LONGWALLS 4 & 5 AND MAINGATES 6, 7 & 8

RESPONSE TO SUBMISSIONS

This document forms NRE's official response to comments received after the public exhibition of its Pt3A modification application for Longwalls 4 & 5 and Maingates 6, 7 & 8. NRE has prepared a Response Report based on Areas of Concern expressed in these submissions. Detailed responses to each submission are included as **Attachment C** to the Report.

Figure 2 Upland Swamps with Revised LW5 Layout

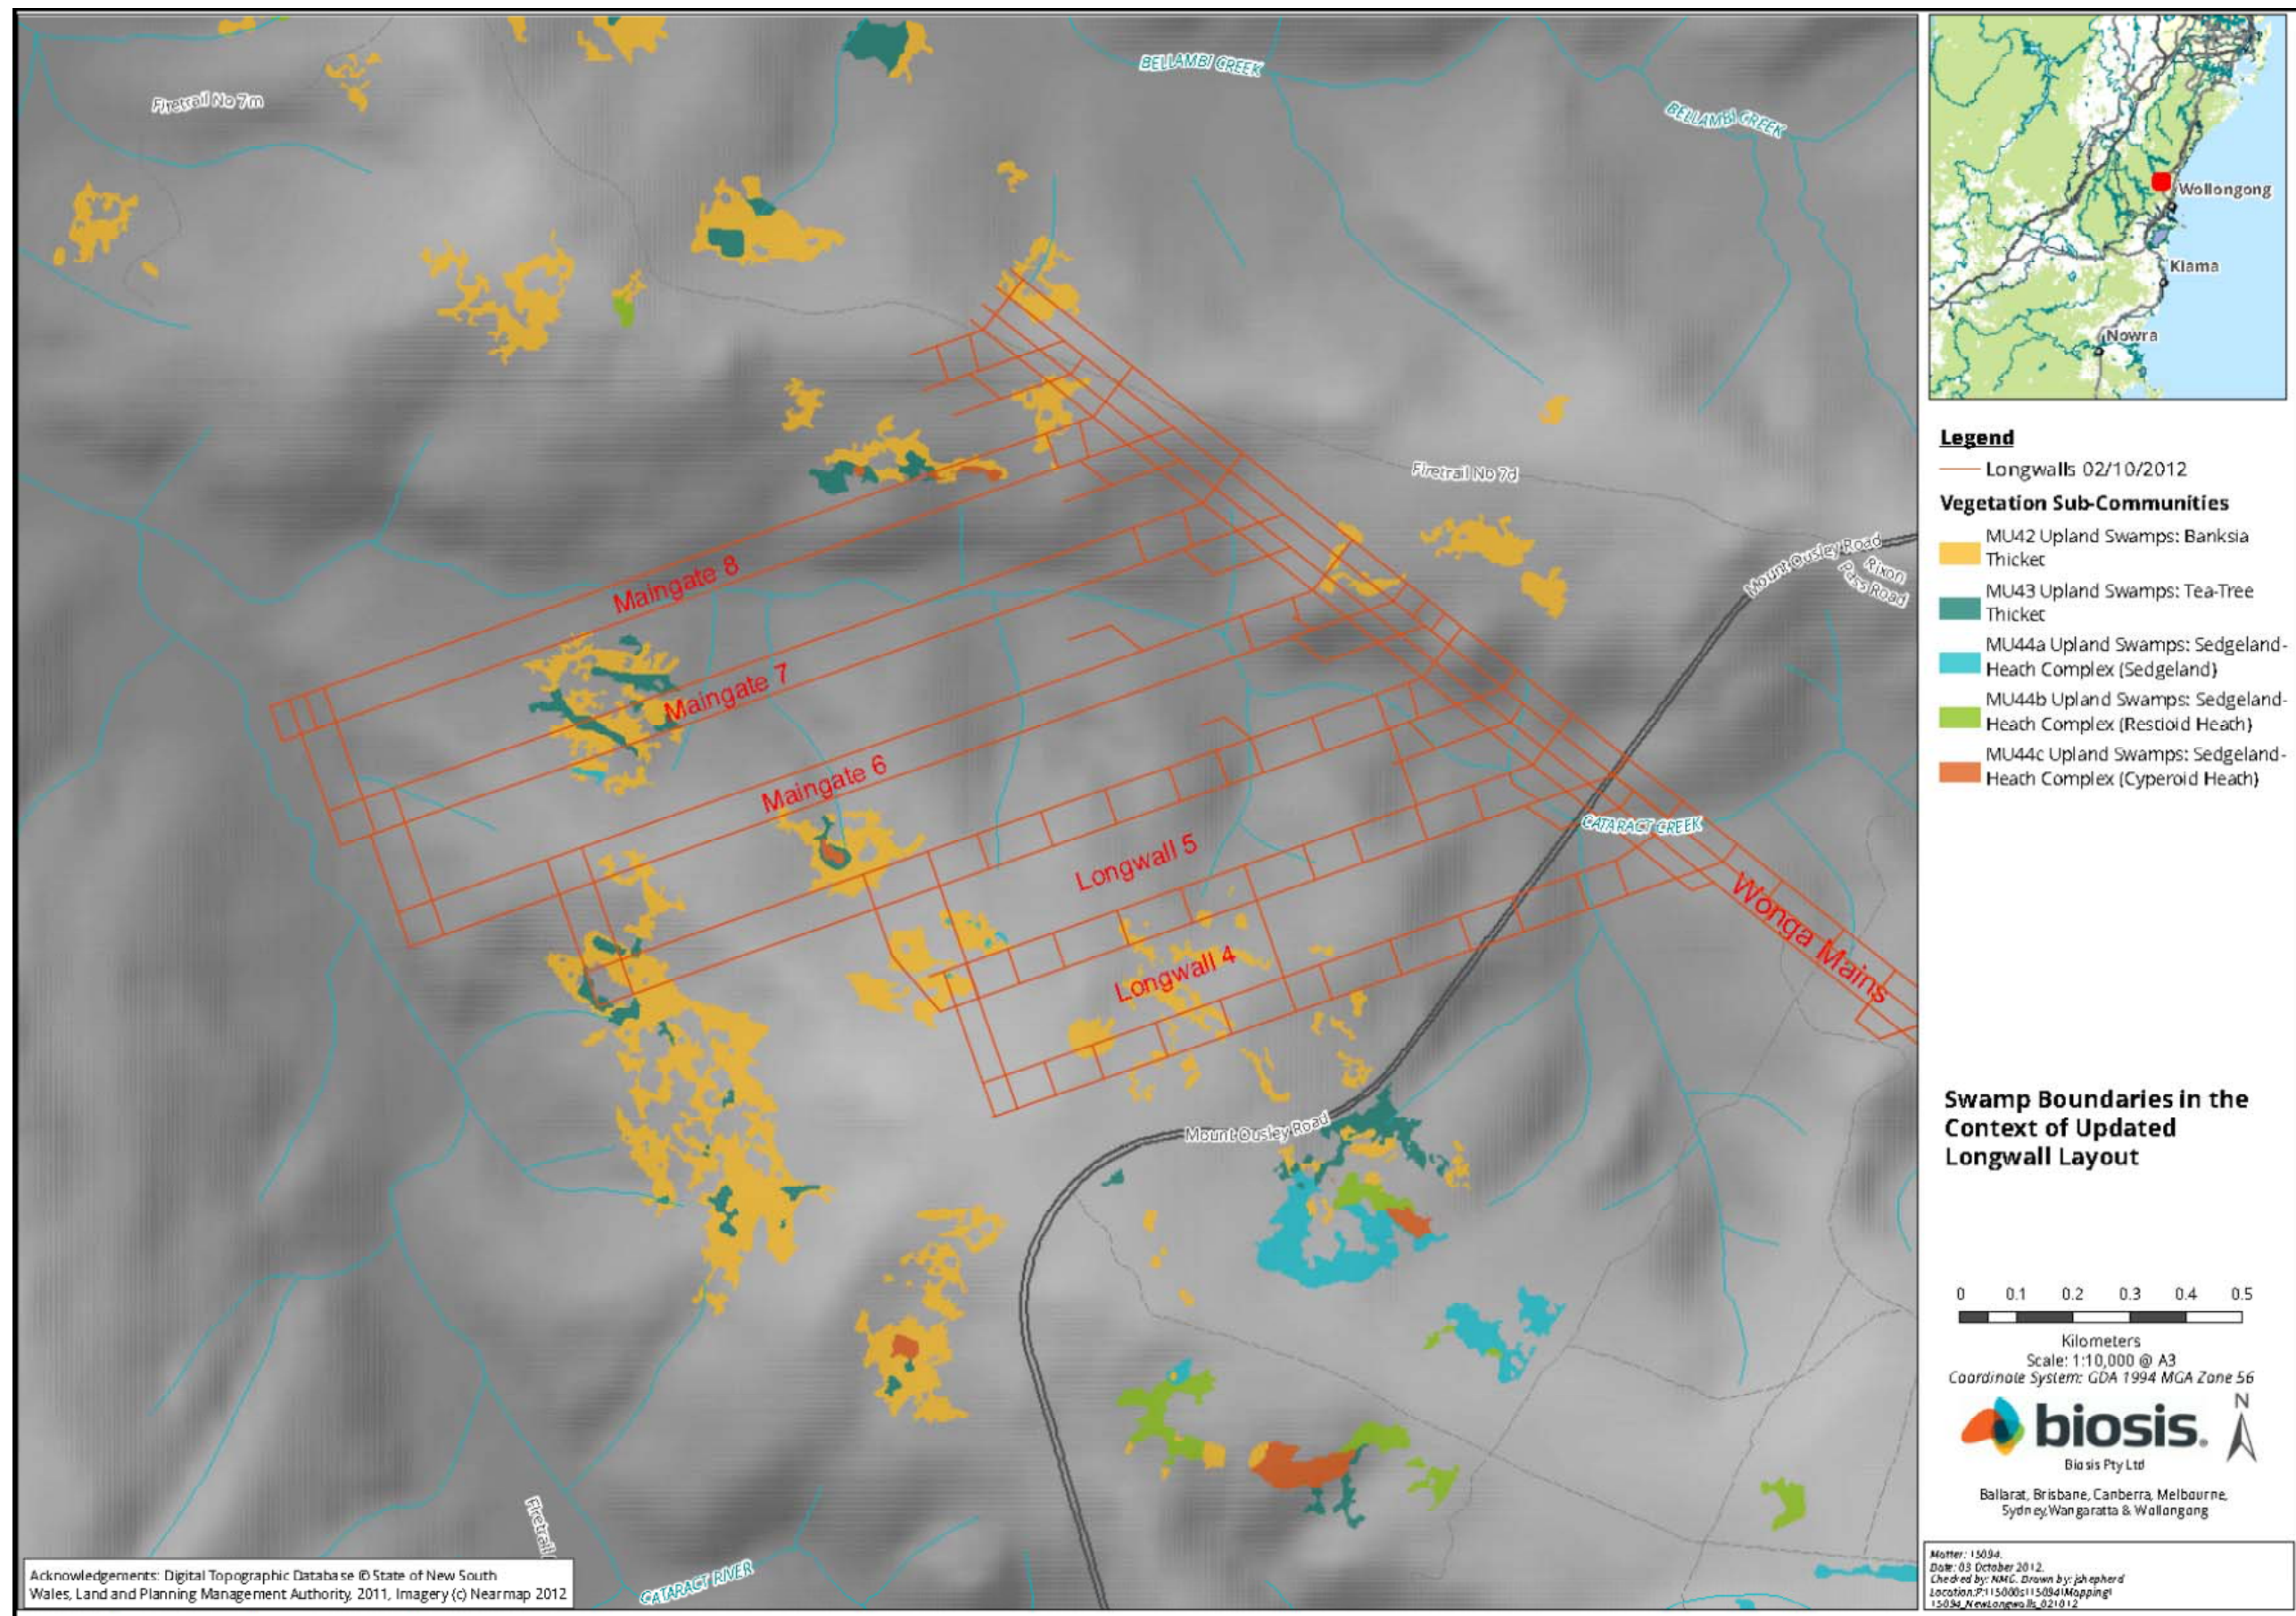
Section 7.2 of the EA addresses issues surrounding the estimated 3.5 ha of swamps located over LW5. The location and designation of the swamps are shown on Figure 9 of the EA. Upland Swamp related issues raised in this Section are dealt with in detail in **Attachment B** of this Response Report. **IMPORTANT NOTE:** The reader must be aware that as a result of the swamp assessment Biosis were required to change the swamp designations used in its report from those used in the EA.

Underground geotechnical assessment has verified the need for NRE to propose a relocation of the LW5 start line adjacent to the LW4 start line. This will lead to a reduced subsidence footprint and potentially reduces surface impacts on sensitive features. The proposed new start line for LW5 is shown in **Figure 2** of this Response Report.

for underground operational reasons NRE proposes to relocate the start position of LW5 adjacent to the LW4 start line thus minimising potential significant impacts to the swamps CCHS4 and CRHS1 from its extraction. This change will be reflected in modified longwall layout plans, subsidence impacts predictions and impact assessments as part of both the Extraction Plan and SMP submissions should this application be approved. The Geoterra assessment does not extrapolate what could or could not occur to CRHS1 to impacts on CCHS3 and CCHS4 that lie within the potential LW4 / LW5 subsidence area. However groundwater monitoring data from CCHS3 has shown that this upland swamp is unlikely to be reliant on perched ephemeral groundwater, but is likely to be reliant on surface water flows and rainfall. As such any fracturing of bedrock below this upland swamp is unlikely to alter baseflow discharges.
